**SUBJECT: NEW VEHICLE DEMONSTRATION / DELIVERY HOLD - Safety Recall 17S15
 – Supplement #6**

Certain 2015-2017 Transit Vehicles Equipped with a Driveshaft Flexible Coupling
 Driveshaft Flexible Coupling Repair

- **Service Action:** *Permanent repairs are now available for all vehicles.*

FIGURE 2

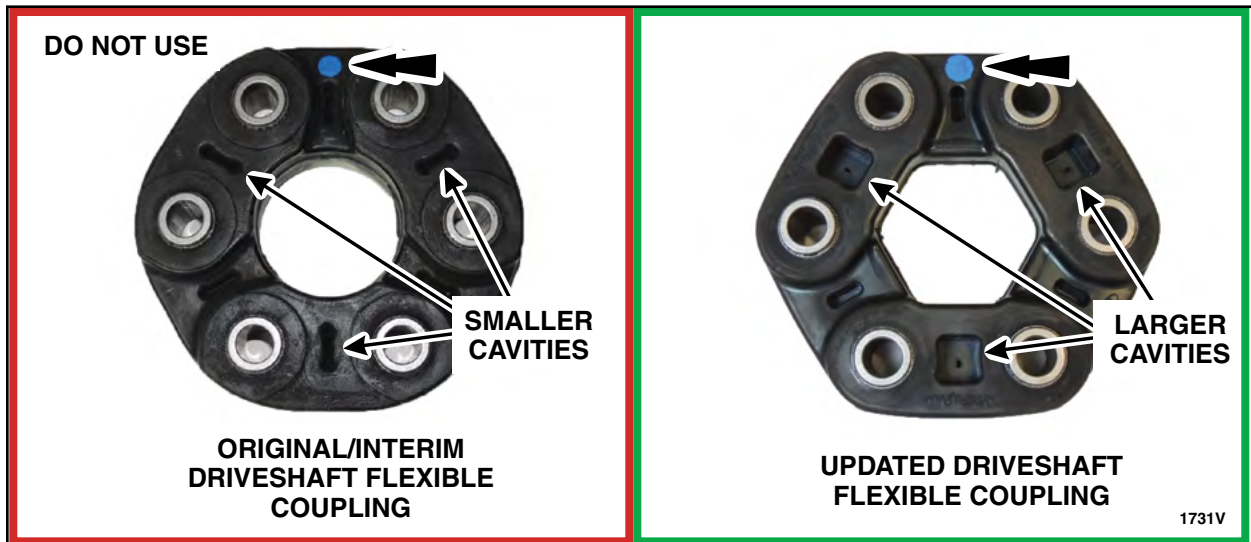
- To assist with the removal of the driveshaft flexible coupling-to-transmission output flange bolts, the use of a Mini-Ductor™ induction heating tool, or equivalent, is recommended.
- The blue paint marking on the new driveshaft flexible coupling must be installed facing the transmission output flange or premature failure of the flexible coupling will occur. See Figure 2.

FIGURE 8

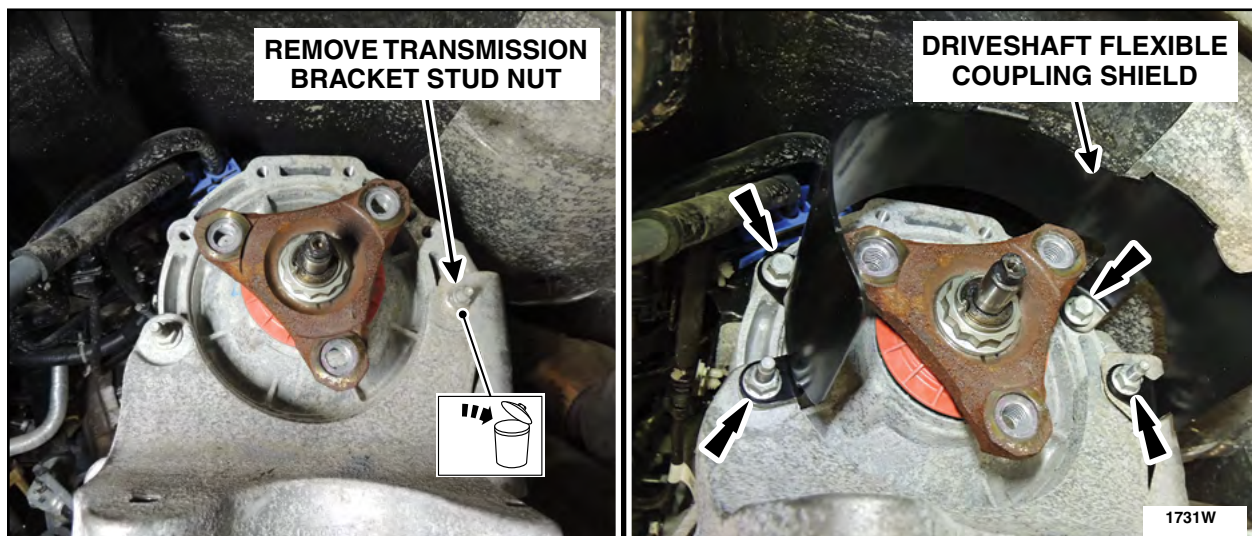
7. Install the driveshaft flexible coupling shield. See Figure 8.

- Remove the upper RH transmission bracket stud nut and discard.
- Install the shield onto the transmission rear housing and bracket.
- Install a new RH and LH transmission bracket stud nut (LH nut is installed over existing nut), and new transmission rear housing bolts to secure the shield.

- Tighten nuts to 23 lb.ft (31 Nm).
- Tighten bolts to 47 lb.ft (64 Nm).

FIGURE 12

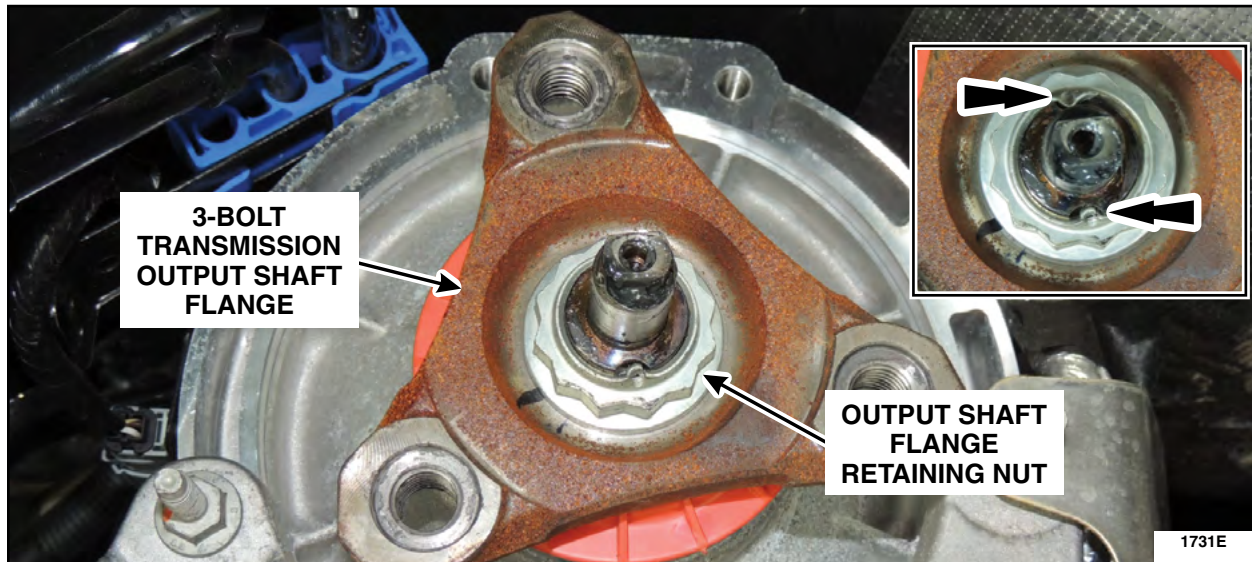
1. Remove the Driveshaft. Please follow the WSM procedures in Section 205-01.
2. Using a 1/2" drive, 34mm, 12-point deep socket, remove and discard the 3-bolt transmission output shaft flange retaining nut and flange. (See Figure 12):

NOTICE: The output shaft flange retaining nut has been staked to prevent it from coming loose. Prior to removing the nut, remove the stake to prevent damage to the output shaft.

- a. Remove the output shaft flange retaining nut stakes.
- b. Place the vehicle in the PARK position and remove and discard the output shaft flange retaining nut.
- c. Remove and discard the 3-bolt transmission output shaft flange.

FIGURE 13

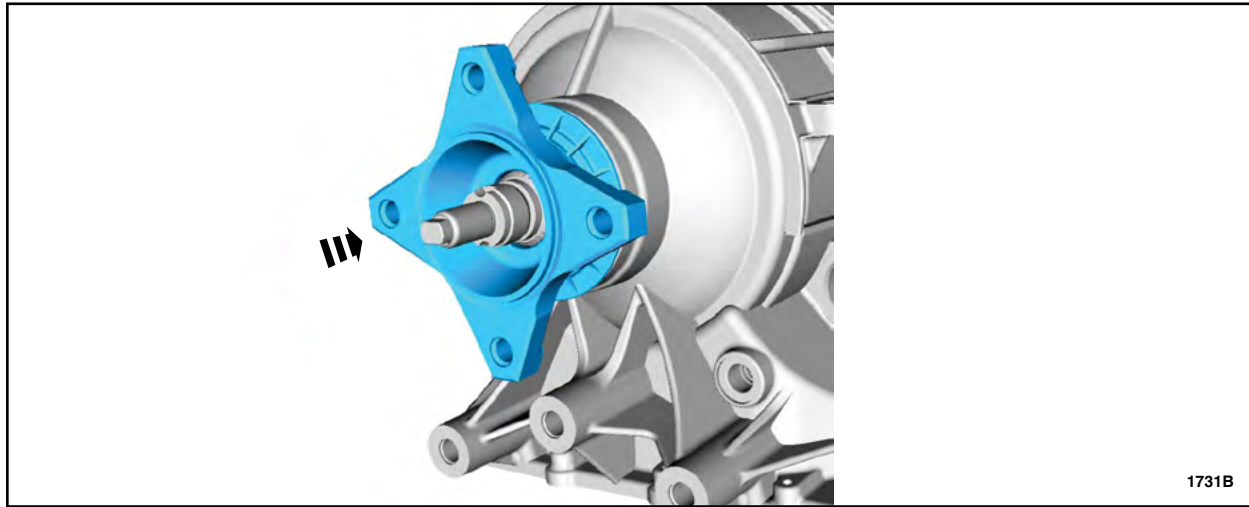
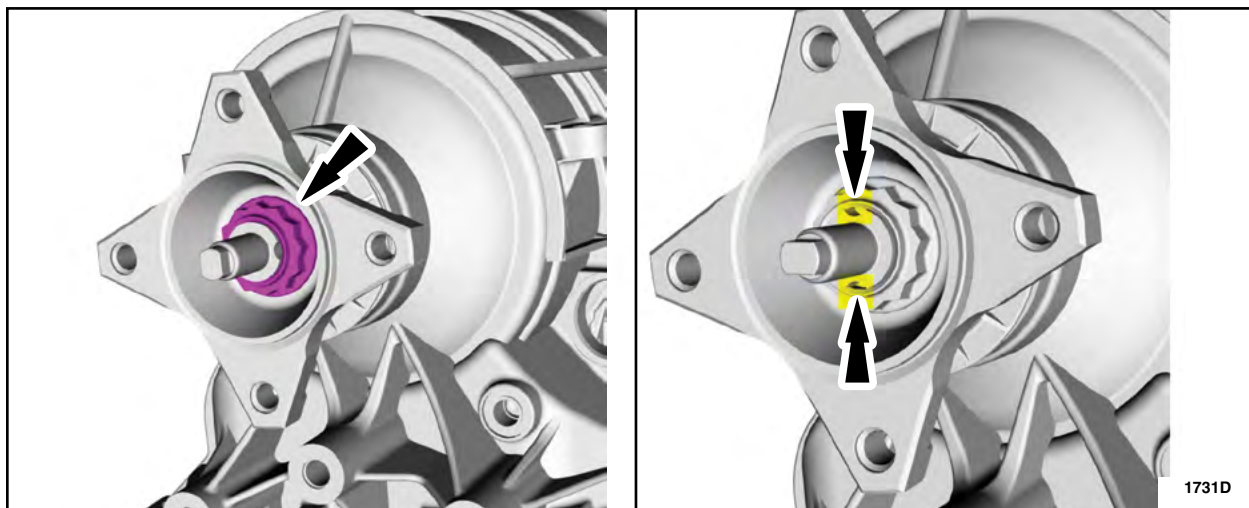
- Using a 1/2" drive, 34mm, 12-point deep socket, install a *new* 4-bolt transmission output shaft flange and retaining nut. (See Figures 13 and 14):

NOTICE: The output shaft flange retaining must be staked to prevent it from coming loose.

- Install a *new* 4-bolt transmission output shaft flange.
- Install a *new* output shaft flange retaining nut.
 - Tighten nut to 59 lb.ft (80 Nm).
- Stake the output shaft flange retaining nut.

FIGURE 16

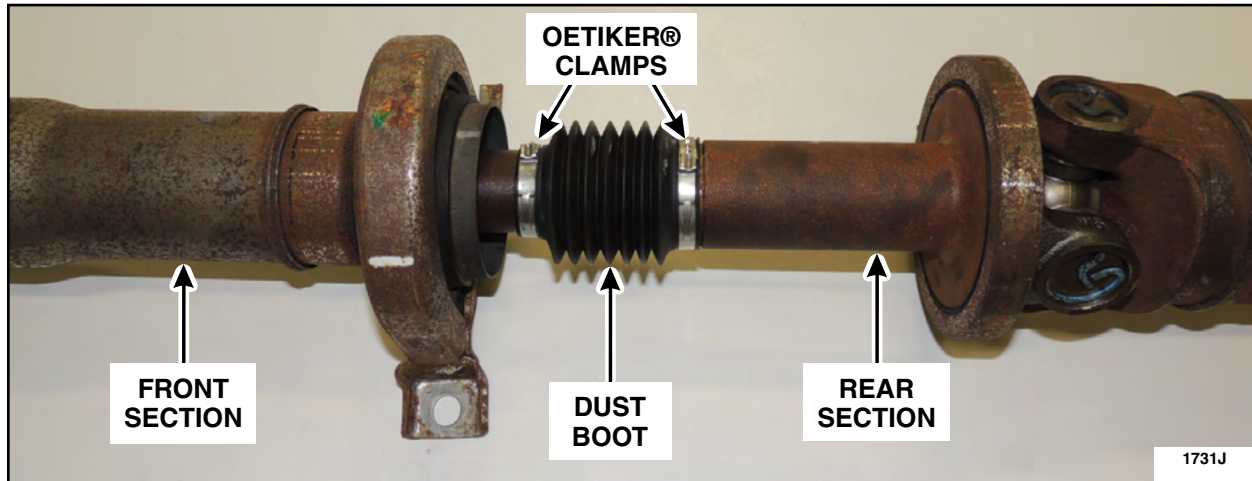
1. Separate the driveshaft front and rear sections at the driveshaft slip yoke. See Figure 16.
 - a. Cut and discard both dust boot Oetiker® clamps.
 - b. Separate the driveshaft front and rear sections.
 - c. Remove and discard the dust boot.

FIGURE 17

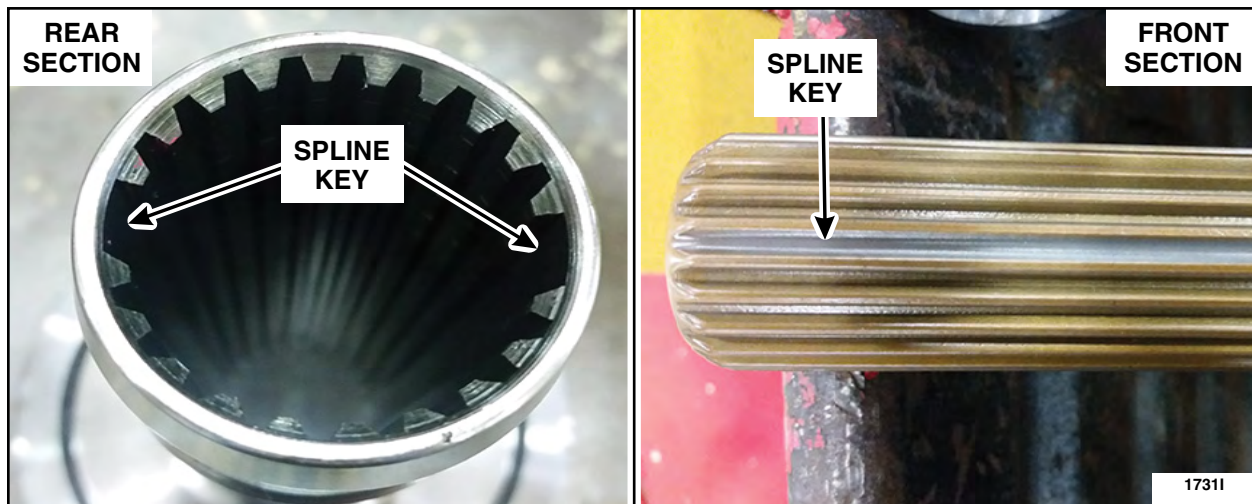
2. Install a *new* driveshaft front section onto the rear section. See Figures 16 and 17.
 - a. Slide a *new* slip yoke dust boot over the driveshaft rear section.
 - b. Lubricate the front section splines using 10-20 grams (0.35 - 0.7 oz) of Motorcraft® XG-8 Driveshaft Slip Yoke PTFE Lubricant.
 - c. Attach the driveshaft front and rear sections. Make sure the front and rear driveshaft spline keys are aligned when mating the two sections.
 - d. Make sure the slip yoke dust boot is properly aligned over each driveshaft section and tighten the dust boot Oetiker® clamps.

FIGURE 18

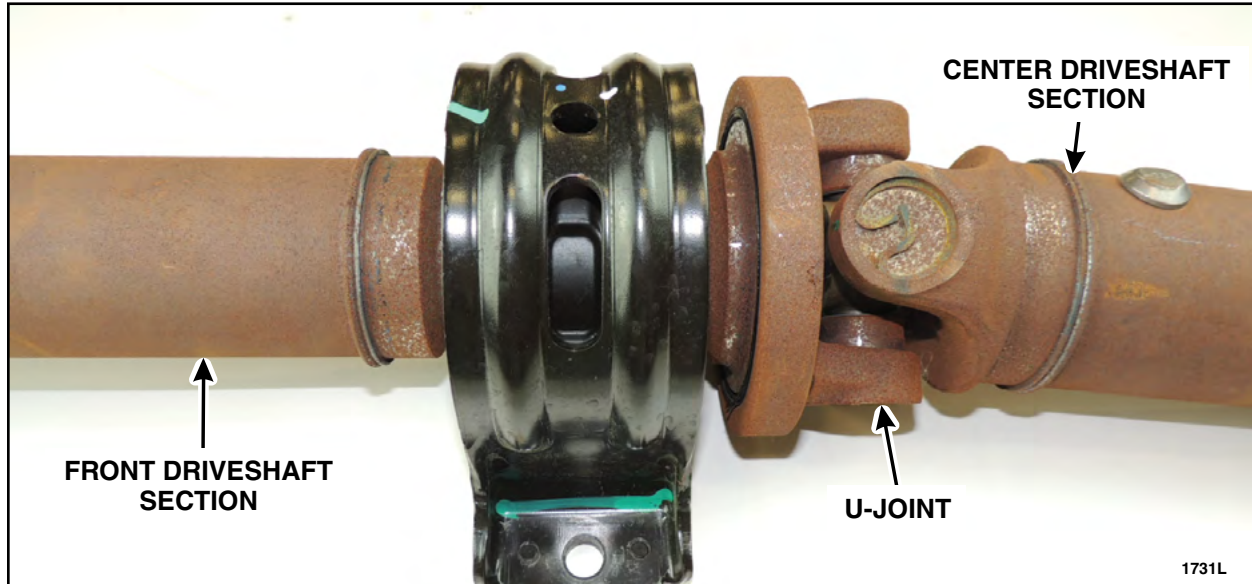
1. Remove and discard the four snap rings and center u-joint to separate the front driveshaft section from the center section. Please follow the Universal Joint Kit Installation Instructions. See Figure 18.

FIGURE 19

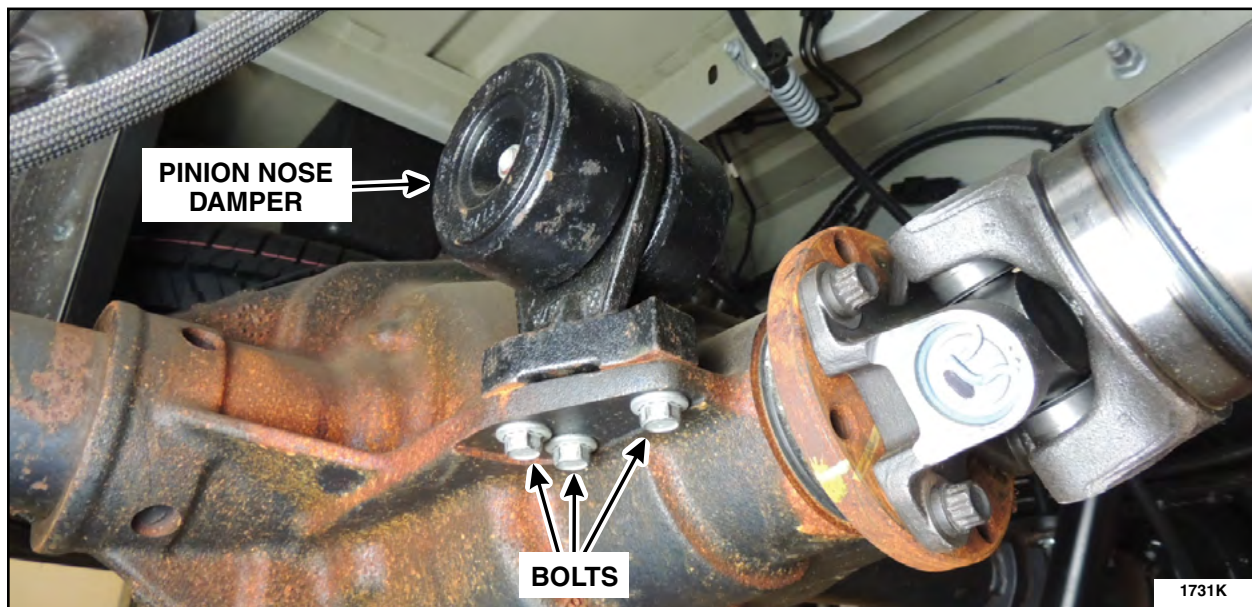
1. If a pinion nose damper is present, remove and discard the three bolts and the original pinion nose damper located on the RH side of the rear axle center housing. See Figure 19.
2. Install a *new* pinion nose damper and tighten the three bolts. See Figure 19.
 - Tighten bolts to 46 lb.ft (62 Nm).

NOTE: Original pinion nose damper is shown. *New* pinion nose damper may appear similar to the original (if equipped), but the dampening characteristics have been changed.
